REPLIES TO COMMENTS OF REFEREE 2 ON: MACRO-ROUGHNESS MODEL OF BEDROCK-ALLUVIAL RIVER MORPHODYNAMICS

FIG. 7. Function $P_r(y)$ Denoting Fraction of Bed Record Measured at Point That Was above Level y , Where y Is Measured Relative to Mean Bed Level, as Determined for Run 33

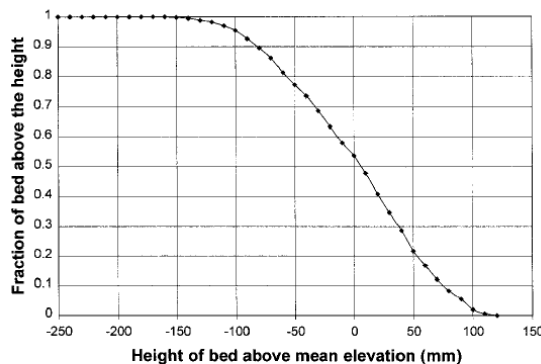
COMMENT The boundary condition as z goes to minus infinity does not make any sense to me. In a physical interpretation, this would imply that there are infinitely deep pockets in the bedrock! It seems to me to be an unsatisfying ad-hoc fix of the before-mentioned problem. At least, the reasoning applied here needs to be much better explained.

REPLY See the material immediately above for what we hope is a much better explanation of the general idea, In regard to infinity, we have reworded as follows. “Instead, in so far as bedrock elevation variation has a random element, which can be seen in Fig. 1, the appropriate conditions are $p_c \rightarrow 0$ as $z \rightarrow -\infty$, and $p_c \rightarrow 1$ as $z \rightarrow \infty$. Here the symbol “ ∞ ” is mathematical shorthand for “appropriately large”.

Please understand that we are talking about a probability distribution. Even a Gaussian distribution has tails, and so do the pdf's used in Lague (2010) for discharge and sediment supply. Please see the figure below from Parker et al. (2000), representing the PDF of bed fluctuations of an alluvial bed covered with dunes. The meaning here is that when the flow has removed all the sediment than it can remove, there are deep pockets, not infinitely deep. where residual sediment will remain, as explained immediately above.
